ADDENDUM #1
North Shore Channel Shoreline Stabilization Bid

Issued May 7, 2026

This addendum is hereby incorporated into the bid documents of the project referenced above. A potential bidder asked the below question. The following item serves as clarification and addition to the bid documents.

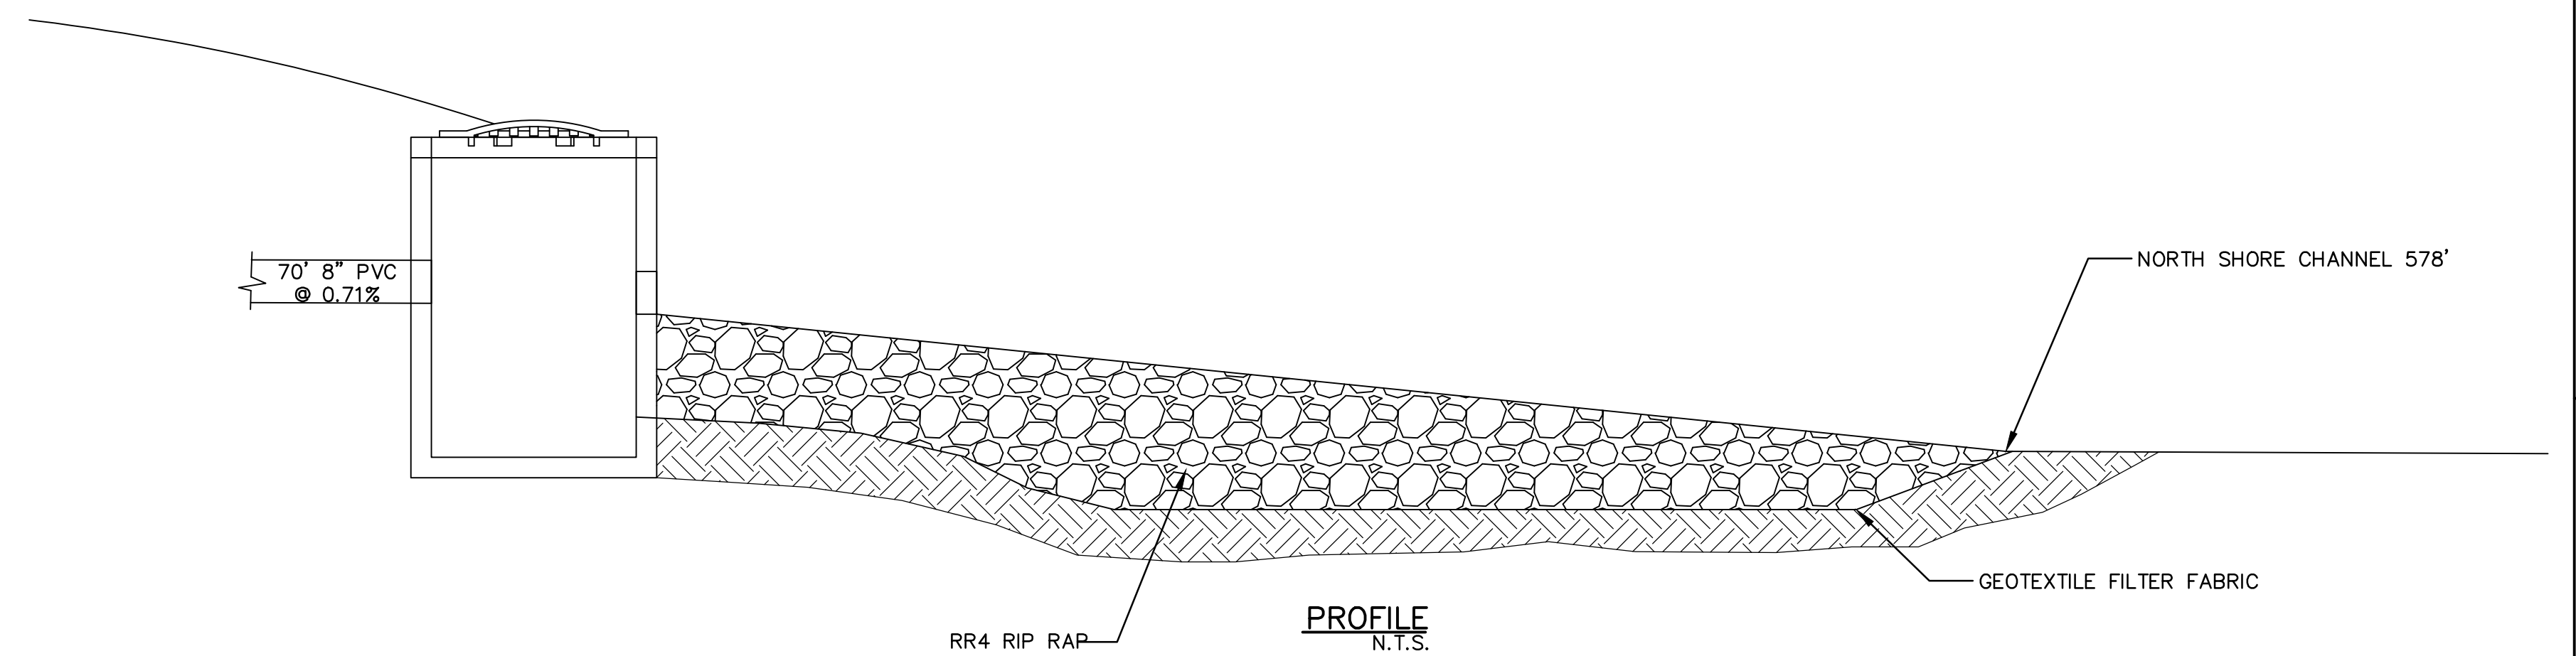
Question: Could you supply a detail for the concrete ribbon curb?

Response: A detail drawing has been provided in conjunction with the Permeable Paver Detail on page C-8.0 of the plan set. Please replace original plan Sheet C-8.0 with Sheet C-8.0 with the Addendum 1 date of 05-07-2026.
